MEMORANDUM

From:	Built Heritage Officer		
Service	Green Infrastructure	App No:	252252 + 252253
Address:	L'Ortolan Restaurant, Church Lane, Shinfield, RG2 9BY		
Proposal:	252252: Householder application for the proposed erection of a rooftop extension with terrace decking to the existing main building, alongside alterations to the fenestration; the erection of a rooftop infill extension to the annex building; the erection of a detached single-storey garage with dual-pitched tiled roof and facing brickwork and stone/render to match the main dwelling; landscaping and parking alterations; and the demolition of the existing single- storey rear kitchen/service extension 252253: Listed Building Consent for the proposed erection of a rooftop extension with terrace decking to the existing main building, alongside changes to fenestration; erection of a rooftop infill extension to the annex building; erection of a detached single storey garage with dual pitched tiled roof and facing brickwork and stone/render to match the main dwelling; landscaping and parking alterations; following demolition of existing single storey rear extension.

Summary Of Recommendations

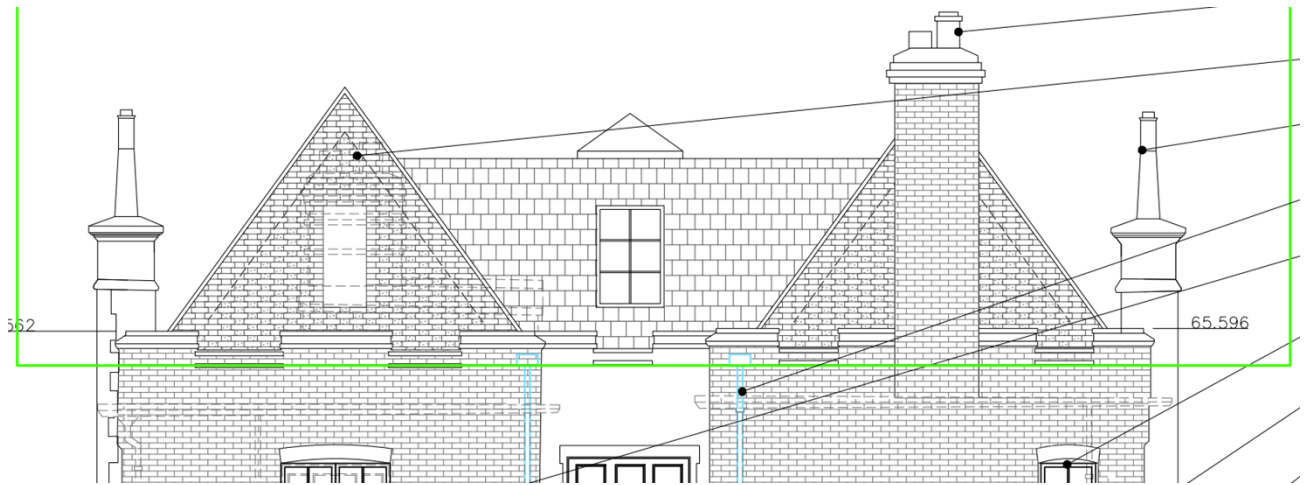
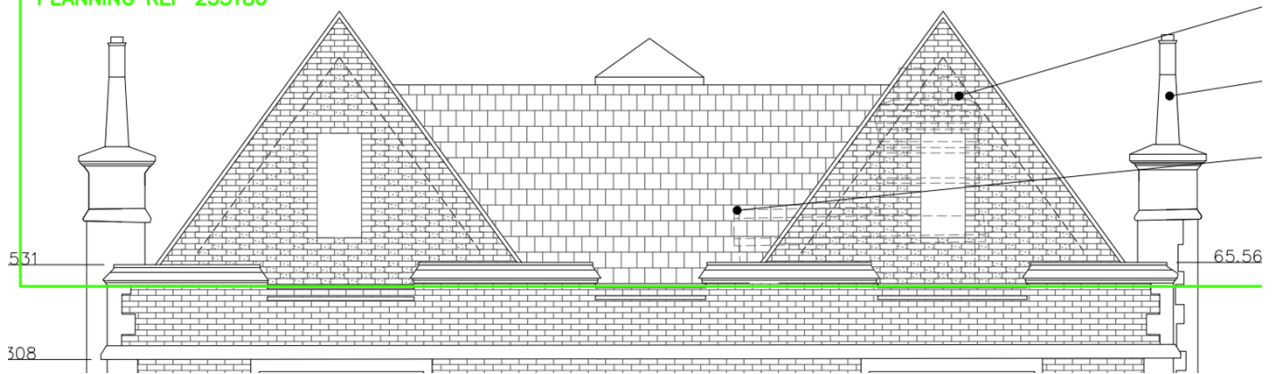
Front elevation – parapet with hipped ends to raised lengths of copings

Rear elevation – raised copings have vertical ends to them except for corner returns.
Rolled tops to coping

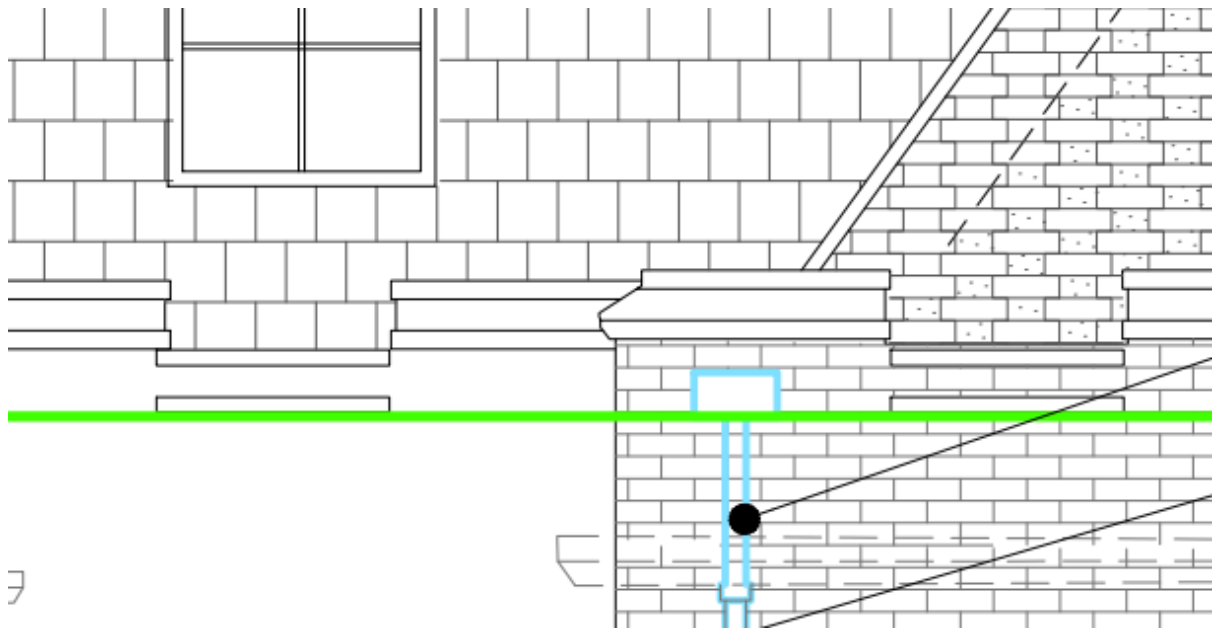
Enlarged extracts of drawing P15 Rev.B showing front and rear parapet walling detailing. – it is however not clear what is happening with respect to the lower sections of the parapet walling on front elevation that appears to show as drawn a single course of brickwork over a thin detail. Whilst on the rear elevation is shown a flat narrow coping to the lower section of the parapet walling with another thin flat coping detail below separated by a single course of bricks.

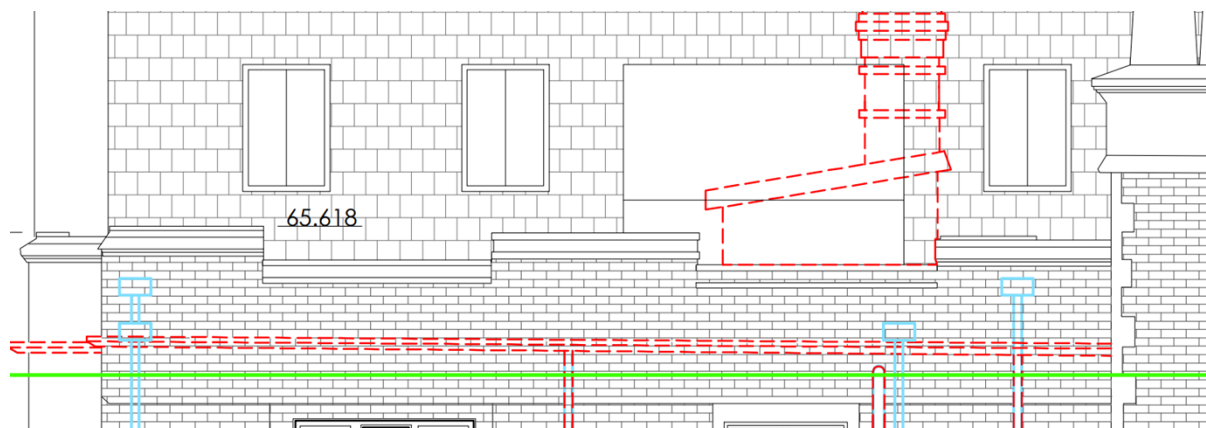
As depicted in the side elevations (P16 Rev. B) and roof plan (P14 Rev. B) appear to depict the front and rear gable ends of the rooftop extension extending out on top of the coping detail of the parapet walling to be in line with masonry walling of the elevations. This is considered to be a somewhat poor detailing in this case. Ideally the ends of the roof preferably should be brought in to be rear of the parapet coping in order to visually better frame the ends of the building.

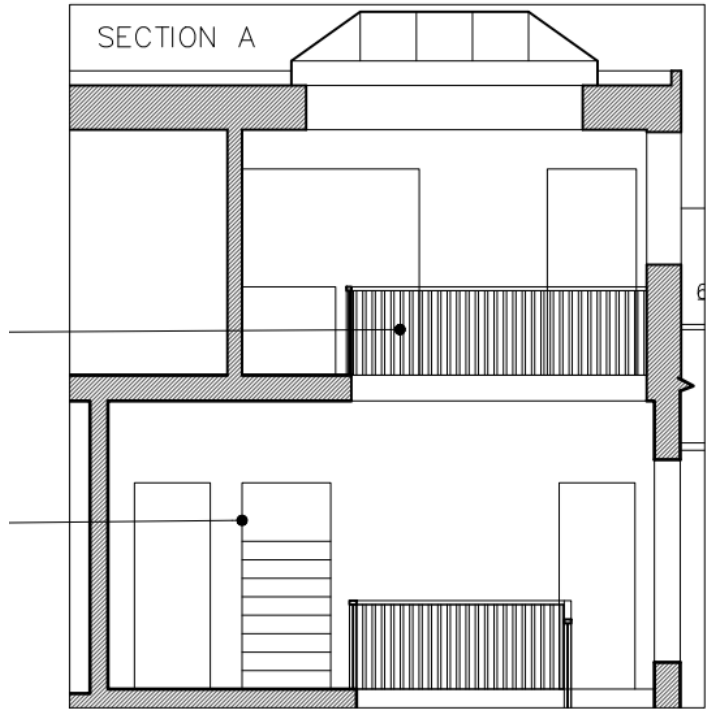
Drawing P14 Rev. A: Proposed Roof Plan – this drawing gives no indication as to how rainwater drainage of the rooftop extension is to be achieved with respect to flat roofed area (though seemingly it the fall of the flat roof would be towards the back of the property to utilize the rainwater drainage around the inset courtyard) or for the frontage area of the roof for the inner facing roof slopes of the pitched roof or the sloping fillet roof element in between.

The section detailing the manner in which the roof along the sides of the building would be formed behind the parapet walling so as to include a hidden drainage channel is acceptable in principle however the form of the parapet is shown as being quite different to what is presently there, which is only one brick length thick and capped with a roll-top 'stone' coping.

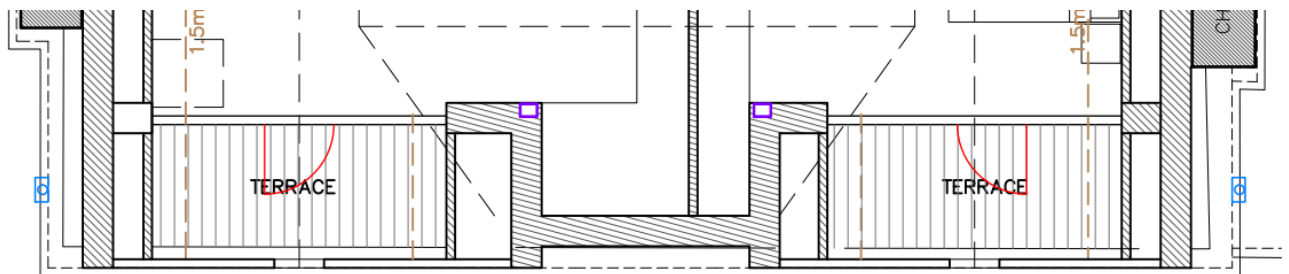
Section A - extract from drawing P13 Rev. B - the section drawing does not answer the questioned raised with respect to what the end elevation to the rooms to the front of the rooftop extension are to be. Also, it is not clear what the shaded triangle projection on the rear elevation is meant to indicate (is this the coping to the rear)?

Off kilter alignment of walling to front & side – extract of drawing P13 Rev.B ?

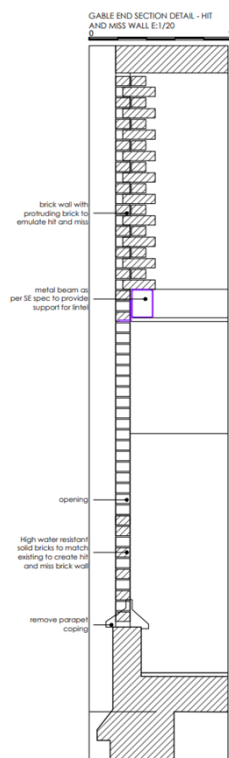
Extract from drawing P16 Rev.B would appear to imply the brick wide hit a& miss lattice gable end walling is to be built off seemingly the existing parapet walling, with the coping whilst shown stated to be removed and not kept. However, on the front and rear elevations of drawing P15 Rev.B show the coping detail.

Also, with the cross-section it is not clear with respect the brick eaves to the gable whether these are to be flush with the end of the roof or with a setback to give an overhang?

In terms of a single brick depth hit and miss lattice walling the gable end there is still concern here as to how safe such an arrangement would be.
